# International Aero Engines SERVICE BULLETIN

Subject: Transmittal of Revision 1 to Service Bulletin  
No.V2500-ENG-72-0305

**V2500-ENG-72-0305**

**ENGINE - LP COMPRESSOR - TO INTRODUCE A CHROME PLATING PIN  
ON THE LPC BLEED VALVE RING**

Booster Stage Bleed Valve and Actuating Mechanism  
Figure 1

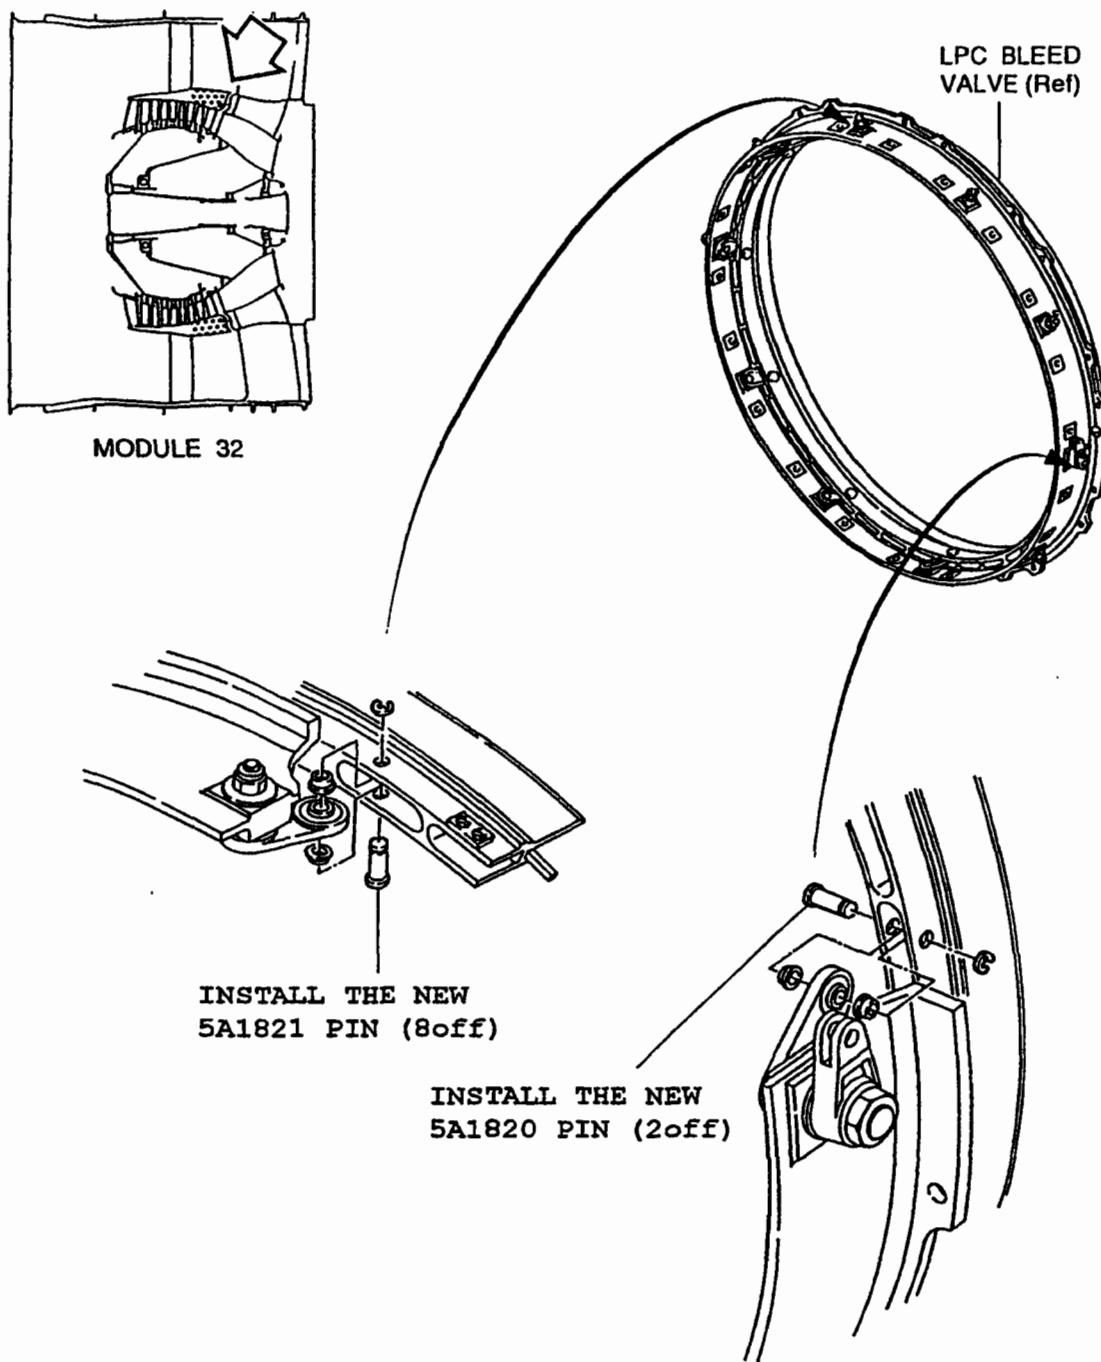
**Install the new pins (5A1820, 2 off and 5A1821, 8 off) in the LPC Bleed Valve Ring. For the correct procedure, refer to the Engine Manual(EM), Chapter/Section 72-32-70, ASSEMBLY-01, CONFIG-2 (For V2500-A5) and Chapter/Section 72-32-70, ASSEMBLY-01 (For V2500-D5). Refer to Figure 1.**
